SERVICE No. 717 BULLETIN

Piper Aircraft Corporation

July 8, 1981

Fuel Selector Line Inspection

FIGURE 1

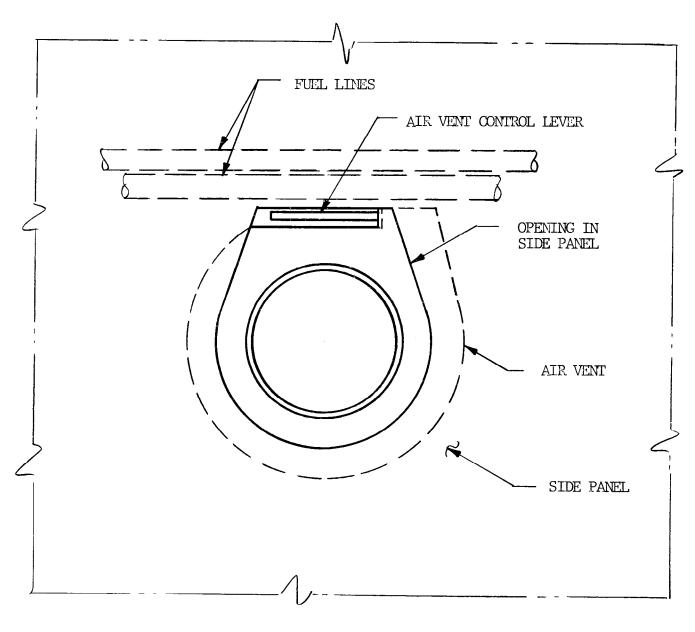
- 3. If clearance is less than .05 inch, fabricate a tool (utilizing the dimensions shown in Figure 1) from a suitable non-metallic material such as wood. Insert tool between fuel line and vent lever. Slide tool forward and aft, at the same time twisting it in each direction, to obtain .05 inch to .15 inch gap.
- 4. Remove tool and, utilizing a suitable mirror, inspect the fuel line for damage such as dents, flat spots, etc.
- 5. If fuel line is worn beyond airworthy limits, remove and replace fuel line; fuel tank drainage may be necessary. (See <u>Material Required</u>.) Install new fuel line and assure clearance as described in Instruction 3.
- 6. Inspect for leaks, reinstall side panel and air vent cover.
- 7. Make appropriate logbook entry of compliance with this Service Release.
